ENGINEERING CHANGE ORDER

REQUEST DATE	7/8/2024	REQUESTED BY	L. HUNT	REQUESTED RELEASE DATE	7/12/2024	ECO #	ECO-00145
AFFECTED PRODUCT LINES	BOARD MOUNTED VALANCES (BMV)						
REASON FOR CHANGE	ELIMINATE BUMP UNDERNEATH FABRIC DUE TO HINGE SIZE.						
DESCRIPTION OF CHANGE	IMPLEMENT NEW PIANO HINGE TO IMPROVE APPEARANCE ON TOP SURFACE						
COST IMPACT	N/A						
DOCUMENT / PART NUMBER	OLD REV	NEW REV	DOCUMENT/ PART DESCRIPTION	CHANGE DESCRIPTION	FORM, FIT, OR FUNCTION AFFECTED Yes, or No	PART DISPOSITION (USE AS IS) (REWORK) (SCRAP) (OBSOLETE) (RETURN TO VENDOR) (OTHER)	
MPMI1591	-	-	HINGE, PIANO 1 IN W 0.113 KD 1569A922, STEEL	RELEASE NEW PART NUMBER COMPONENT: SAME AS PART NUMBER COLOR: N/A STOCK CLASS: ROLLER PARTS PU: EA RU: EA RF: 1 CRITICAL: NO CO: USA	NO	-	
N/A	-	-	IMPLEMENT NEW PIANO HINGE ON BOARD MOUNTED VALANCES (SEE ENG TEST REPORT ON PAGES 3-8)	CHANGE FROM MPMI0195 TO MPMI1591 ON BMV WITH WIDTHS ABOVE 72"	YES	N/A

REPORT TITLE:	BMV LOW PROFILE PIANO HINGE	REPORT DATE:	07/02/2024
REPORT NUMBER:	ENGREP098	CREATED BY:	J. Ruiz
QA & ENGINEERING APPROVAL	CC:		
H. Amezcua	L. Hunt, L. Hernandez, M. Chang, H. Amezcua.

Photo 1 and 2. Customer claim from order 2008518

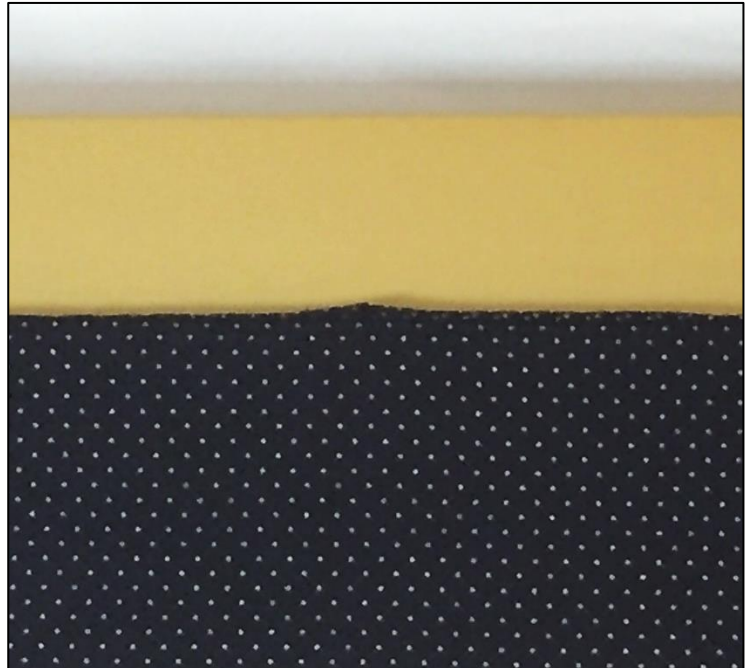
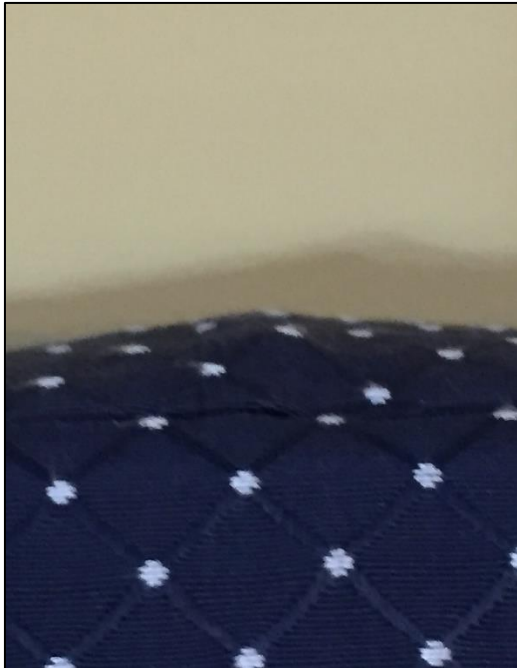
This test is intended to evaluate a potential change to resolve a problem for customers that don't like the appearance of the top surface of BMV because of the "bump" created under the fabric by the large door hinge used. Particularly for BMV that are wider than 72 inches. This issue has been subject of customer claims and remakes.

Photo 6 and 7. Current Hinge MPMI0195 (McMaster Part Number: 1608A54)

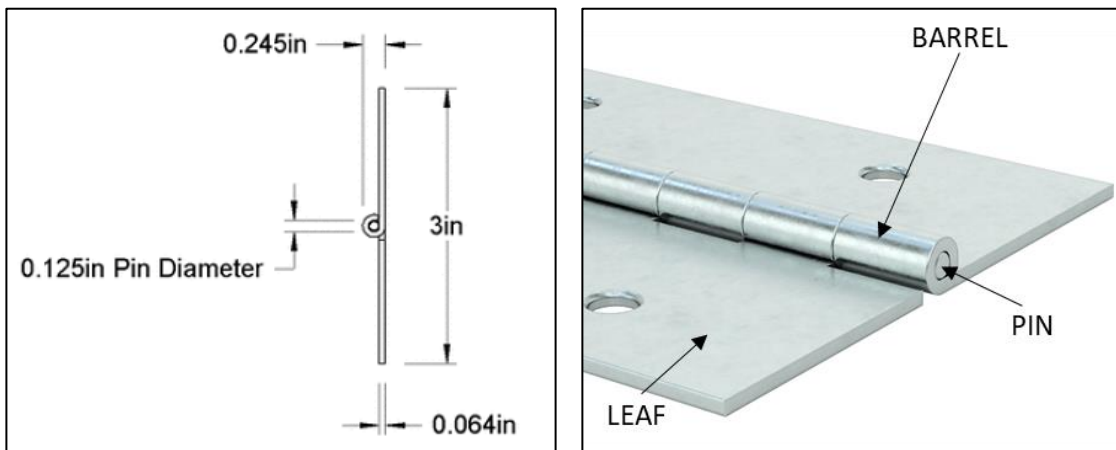
After analyzing the current manufacturing method for BMV wider than 72 inches, we found that we are using what we believe is a piano hinge that is too robust for this application. The pin and barrel are too large in diameter which creates the bump above the valance when mounted. The layers of fabric on top also add to this undesired effect.

- We recommend changing the type of piano hinge to the proposed part (1569A922) as we think this is adequate for this type of application.
- The proposed piano hinge is \$14 USD cheaper than the current one.
- The proposed piano hinge helps us achieve an almost flat surface on top which can eliminate the appearance issue which have created customer claims and remakes requests.
- The proposed change will only be applicable to BMV above 72 inches wide.

Photo 8 and 9. Proposed Hinge (McMaster Part Number: 1569A922)

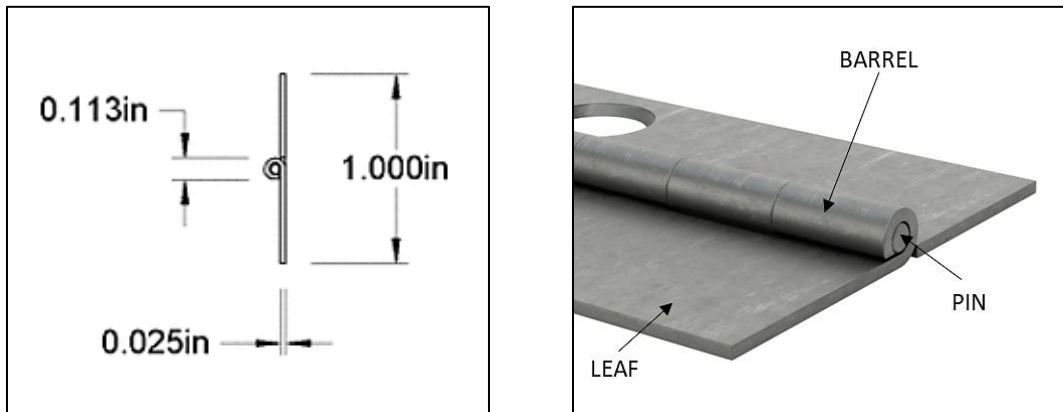
We tested a different piano hinge that we believe is better suited for this type of application. After evaluating different options from the same supplier, we performed an assembly and functionality test with another piano hinge sample.

Photo 11, 12 and 13. Proposed Hinge Assembly Test

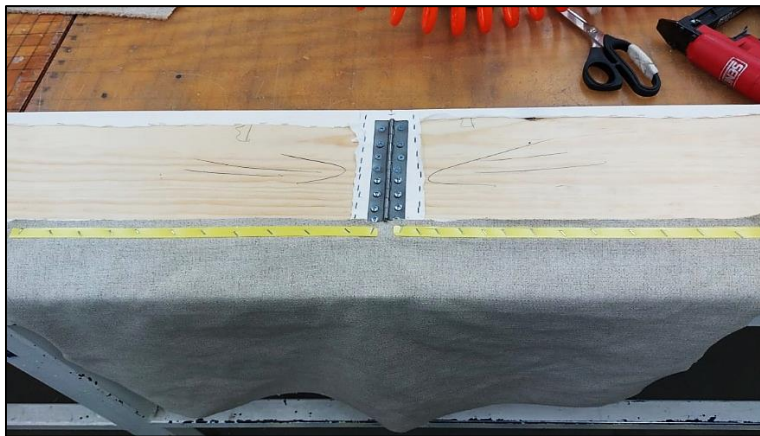
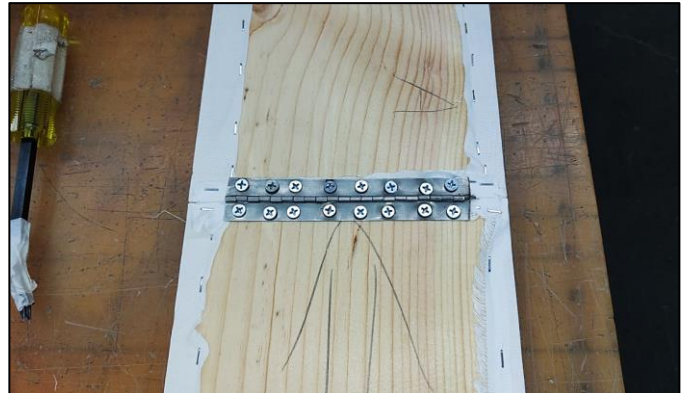
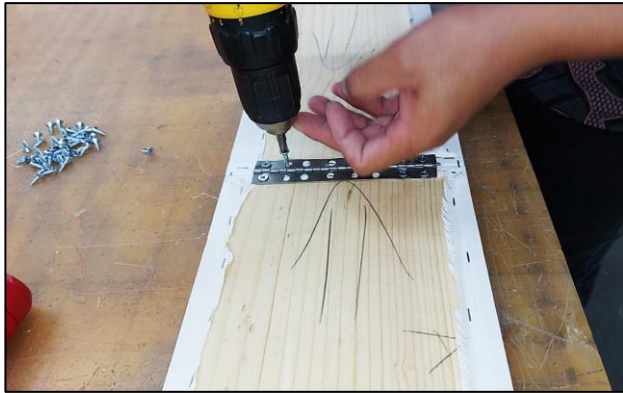
The assembly test was performed with a large BMV at 144 inches wide and 7 inches board.
